**Recreational Vehicle Safety Recall Notice**

Safety Recall: 22V358

RE: NHTSA RECALL 22E021 for Dometic CE99-ZF and PI8022 COOKTOPS

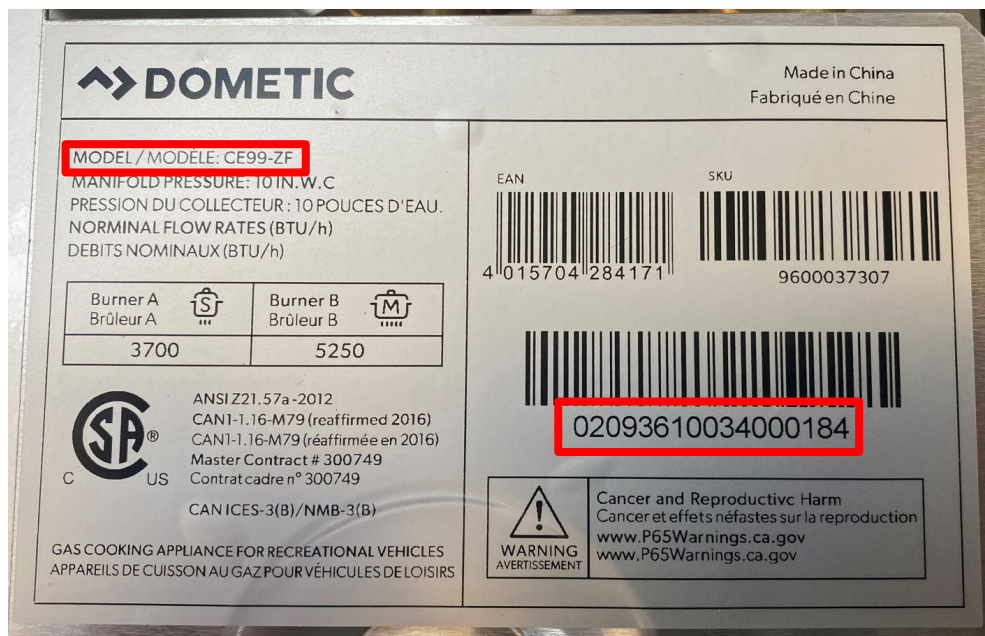
The user of a recreational vehicle or marine vessel may become aware of the potential safety-related defect during operation of the cooktop. The burner control valve, mated directly to the control knob via the valve stem, may leak gas. This gas will leak directly into the recessed portion of the cooktop, where the knobs and ignitor are located, and may be ignited by the active burner(s). The ignition will result in a small pilot flame directly at the control knob.

The recall population consists of cooktop models CE99-ZF and PI8022 with the affected serial numbers indicated below.

- CE99-ZF: Cooktop with two burners and safety glass cover
  - 02093610034000001 – 02093610034000600
  - 11993610034000001 – 11993610034000510
  - 12593610034000001 – 12593610034000500
- PI8022: Cooktop with two burners and safety glass cover
  - 11093610034600001 – 11093610034600550
  - 12393610034600001 – 12393610034600550

IF YOU OWN ONE OF THE UNITS SHOWN ABOVE, YOU MUST IMMEDIATELY SHUT THE GAS OFF AT THE RV LP TANK REGULATOR. THEREAFTER, DO **NOT** ATTEMPT TO USE LP GAS WITHIN THE RV UNTIL THE COOKTOP HAS BEEN REMEDIATED IN ACCORDANCE WITH THIS RECALL.

4. The remedy will be available for field installation at Dometic authorized service centers or participating OEM locations after May 13, 2022 and will be installed at **NOT COST** to you. The remedy for an affected unit will be a complete replacement of the cooktop. The Dometic Authorized Service Center will install the remedy for you. This repair will take approximately one and a half hours to complete.
